HISTORIC AND DESIGN REVIEW COMMISSION

HDRC CASE NO: 2023-023
COMMON NAME: 2219 W Gramercy
LEGAL DESCRIPTION: NCB 6820 BLK LOT 7
ZONING: R-6, H
CITY COUNCIL DIST.: 7
DISTRICT: Monticello Park Historic District
APPLICANT: James Bailey
OWNER: James Bailey
TYPE OF WORK: New construction of a 2-story, single-family
APPLICATION RECEIVED: January 13, 2023
60-DAY REVIEW: Not applicable due to City Council Emergency Orders
CASE MANAGER: Jessica Anderson

The applicant is requesting a Certificate of Appropriateness for approval to construct a new two-story, single-family residence at 2219 W Gramercy.

2219 W. GRAMERCY PLACE - SINGLE FAMILY HOME
MASSING DIAGRAM

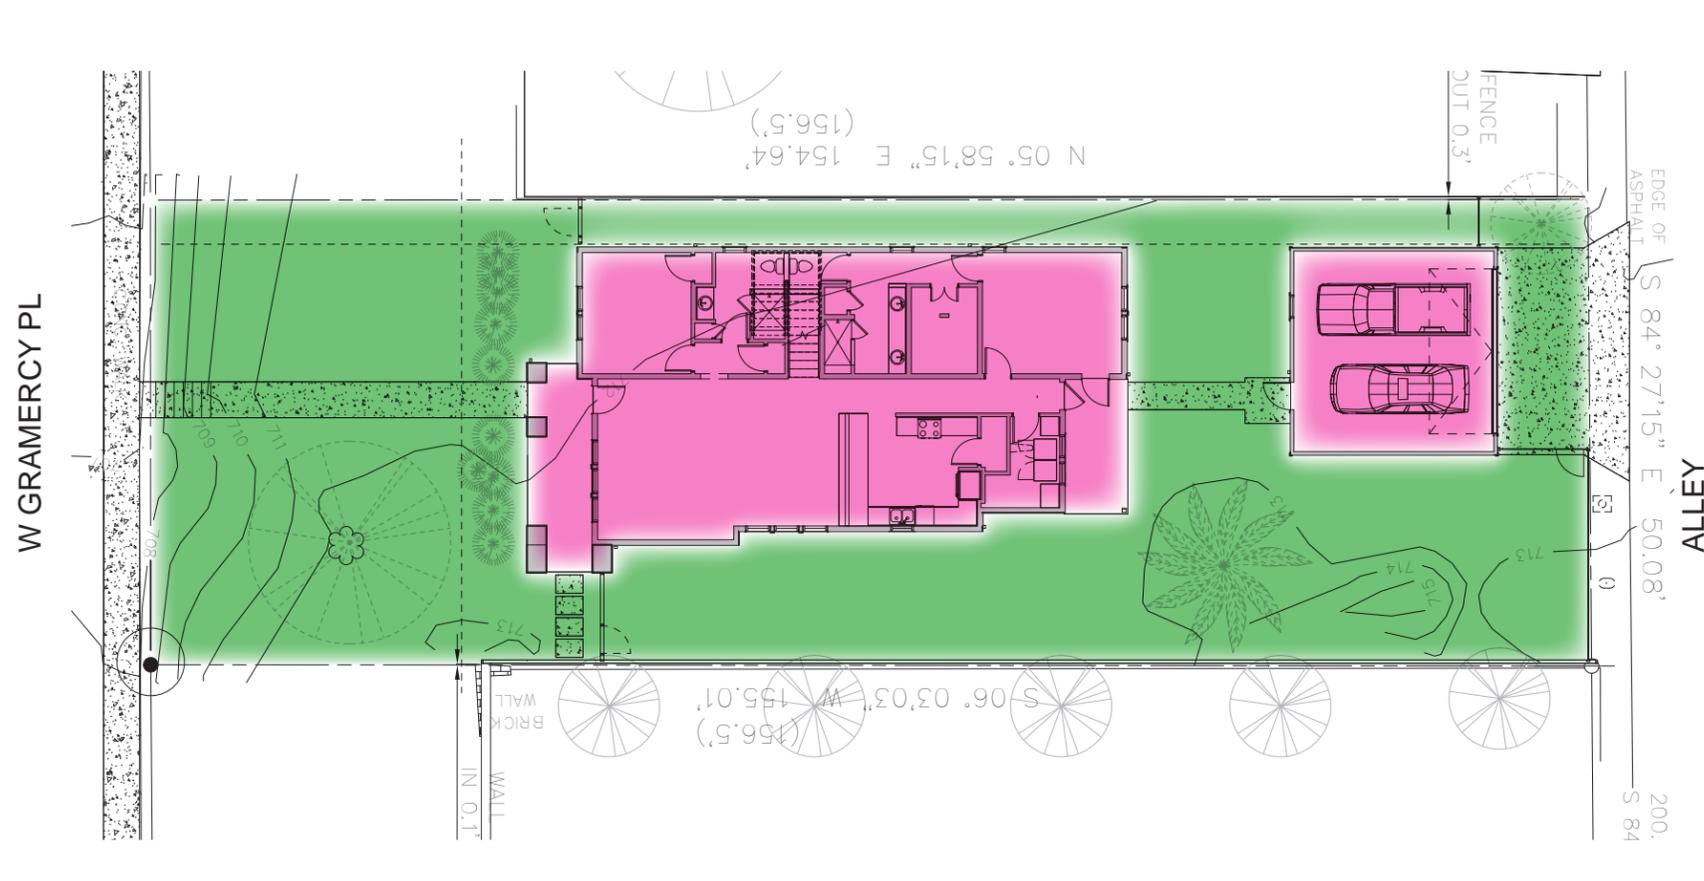
- PAGE 6 -** i. That the applicant submits a diagram showing the scale and massing relative to adjacent structures to staff for review prior to returning to the issuance of a Certificate of Appropriateness based on finding d.

2219 W. GRAMERCY PLACE - SINGLE FAMILY HOME
SQUARE FOOTAGE | LOT COVERAGE

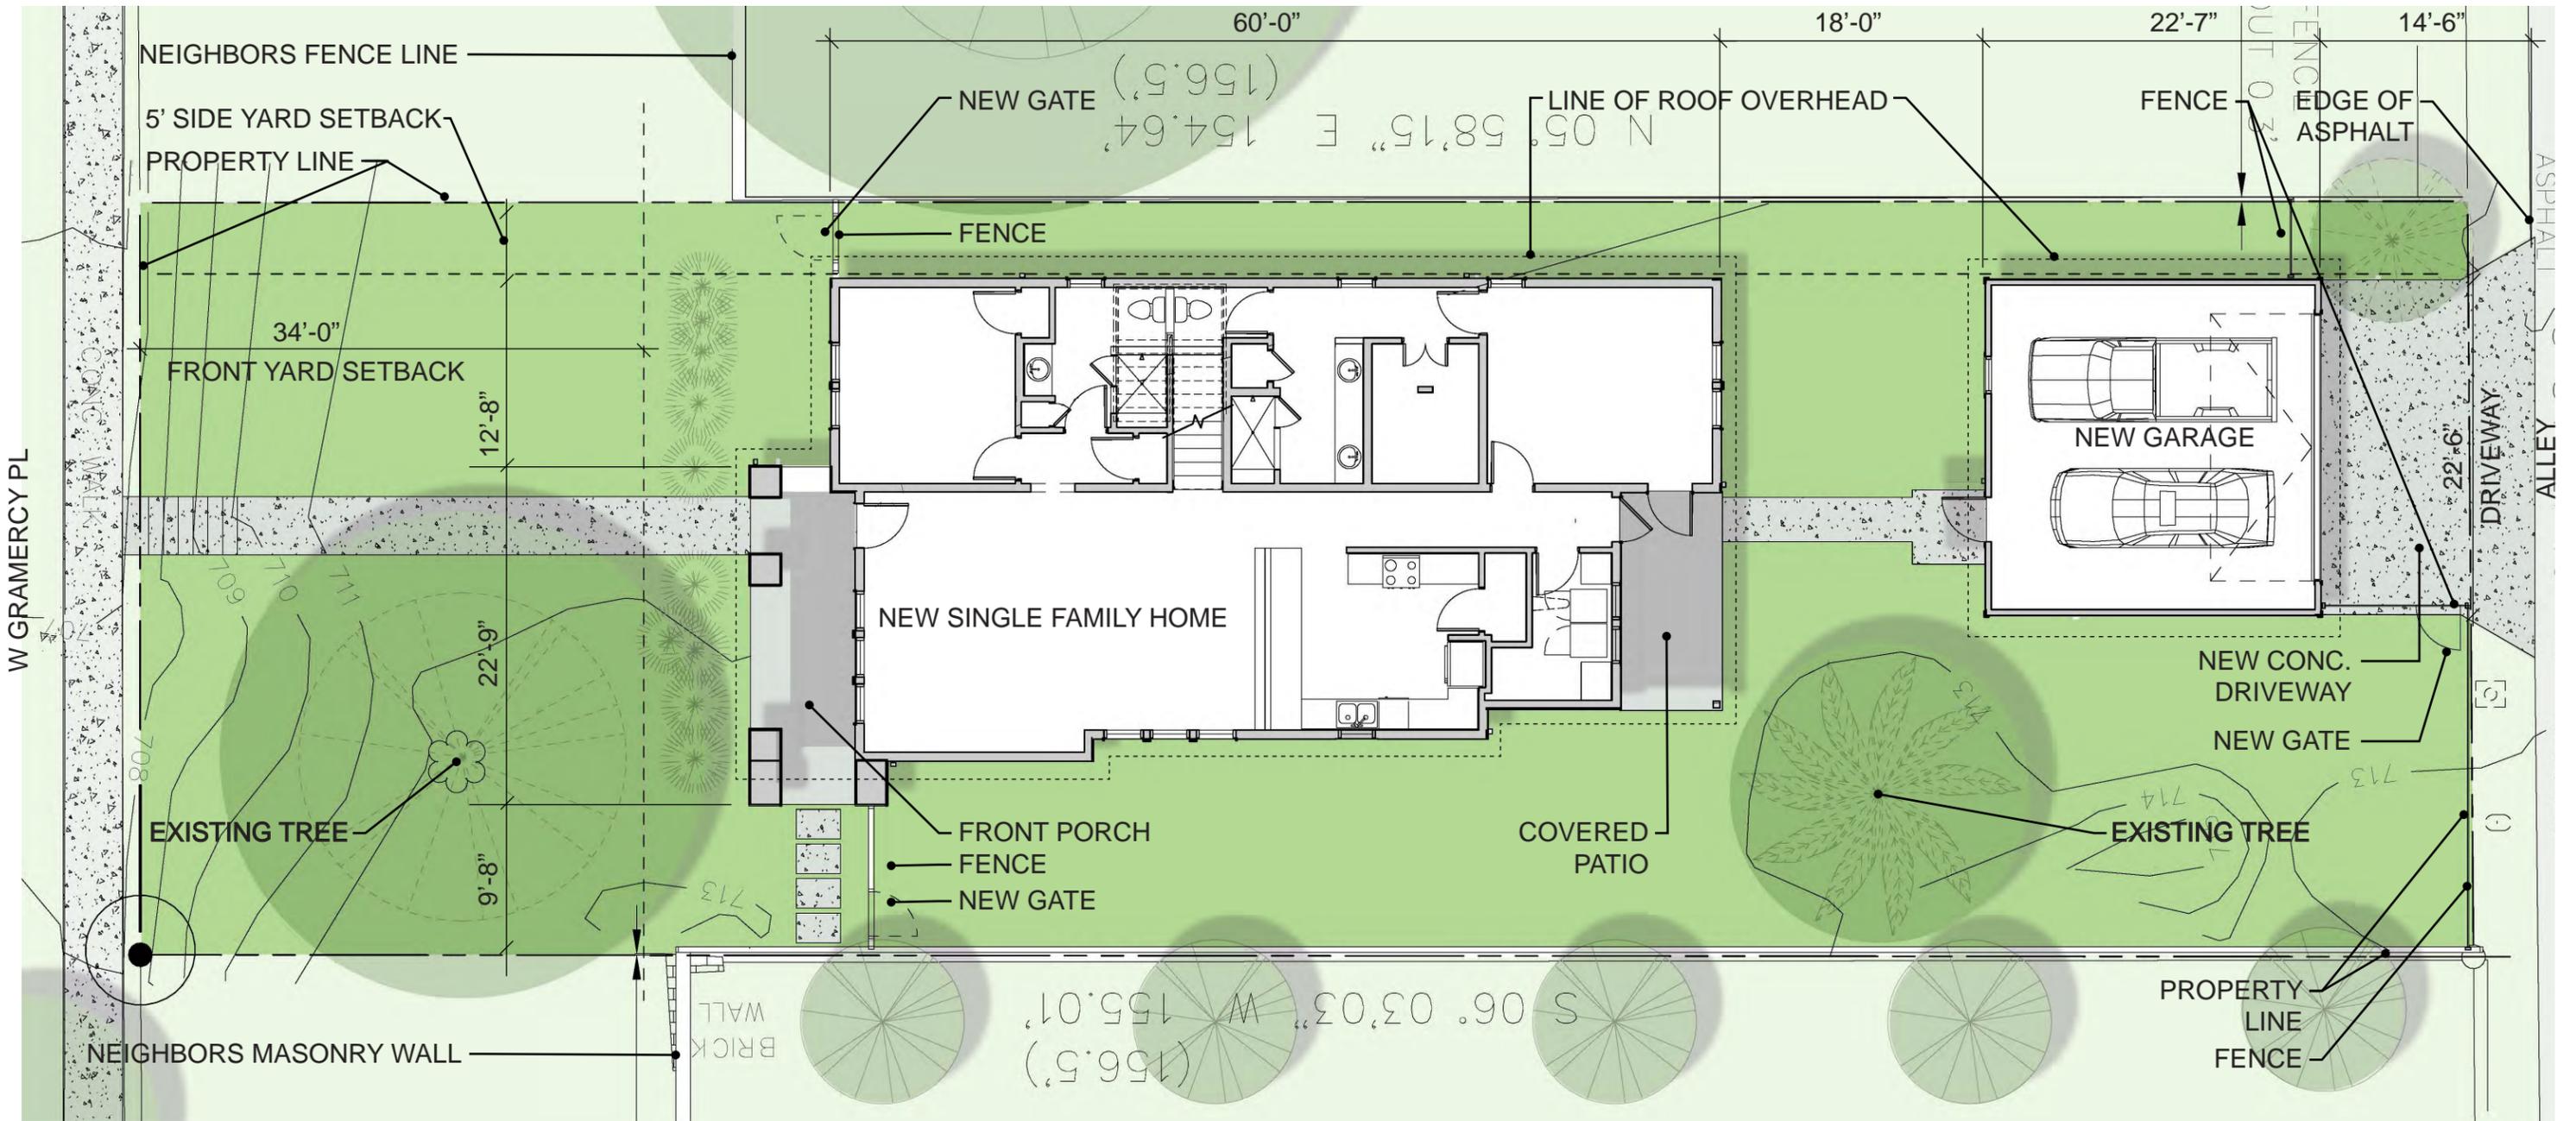
- PAGE 7 -** ii. That the applicant submits the total square footage and the percentage of lot coverage to staff for review prior to the issuance of a Certificate of Appropriateness based on finding f.

LAND SQUARE FOOTAGE:	7,875.65 SQ. FT. (BCAD)
	BUILDING FOOTPRINT:	2,452 SQ. FT.
	PERCENTAGE OF LOT COVERAGE:	31%

**2219 W. GRAMERCY PLACE - SINGLE FAMILY HOME
WINDOW SPECIFICATIONS | GARAGE DOOR**

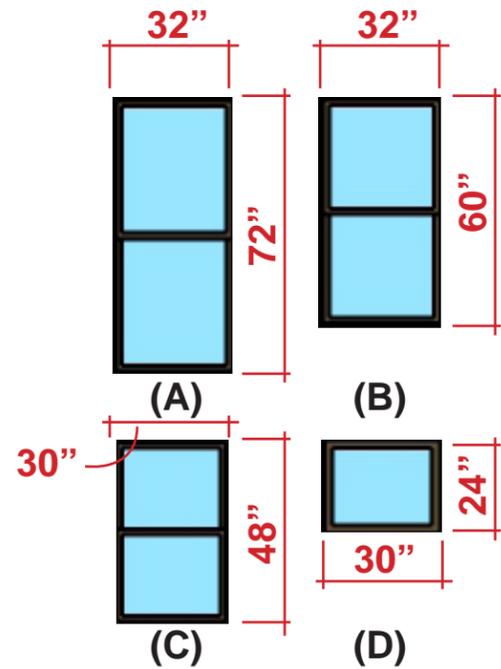
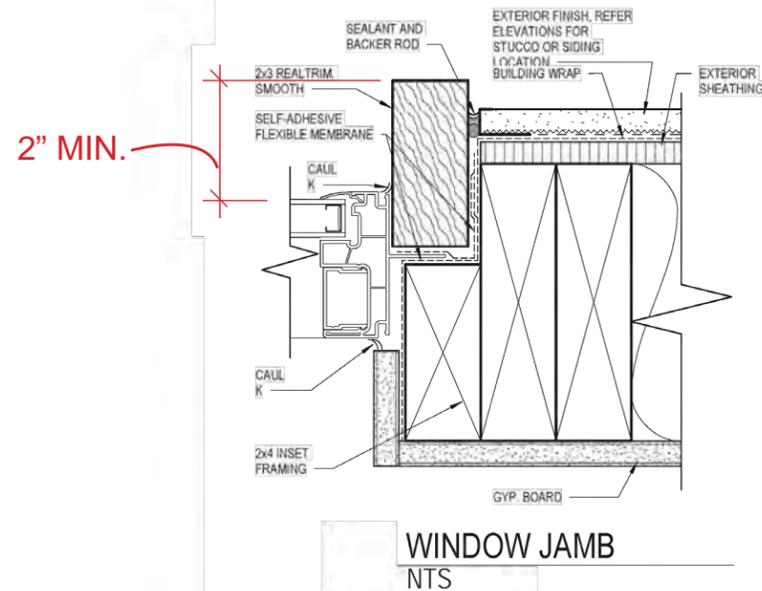
- DESIGN ELEMENT HAS BEEN ELIMINATED -** iii. That the proposed cornice features a traditional or troweled finish based on finding g.
- PAGE 18 -** iv. That the applicant submits final window specifications to staff for review prior to the issuance of a Certificate of Appropriateness based on finding g. Wood or aluminum-clad wood windows are recommended and should feature an inset of two (2) inches within facades and should feature profiles that are found historically within the immediate vicinity. An alternative window material may be proposed, provided that the window features meeting rails that are no taller than 1.25” and stiles no wider than 2.25”. White manufacturer’s color is not allowed, and color selection must be presented to staff. There should be a minimum of two inches in depth between the front face of the window trim and the front face of the top window sash. This must be accomplished by recessing the window sufficiently within the opening or with the installation of additional window trim to add thickness. Window trim must feature traditional dimensions and architecturally appropriate sill detail. Window track components must be painted to match the window trim or concealed by a wood window screen set within the opening.

- PAGE 8 & 18 -** vi. That the applicant submits the total square footage of the garage and final material specifications for the proposed garage doors to staff for review prior to the issuance of a Certificate of Appropriateness based on finding k.
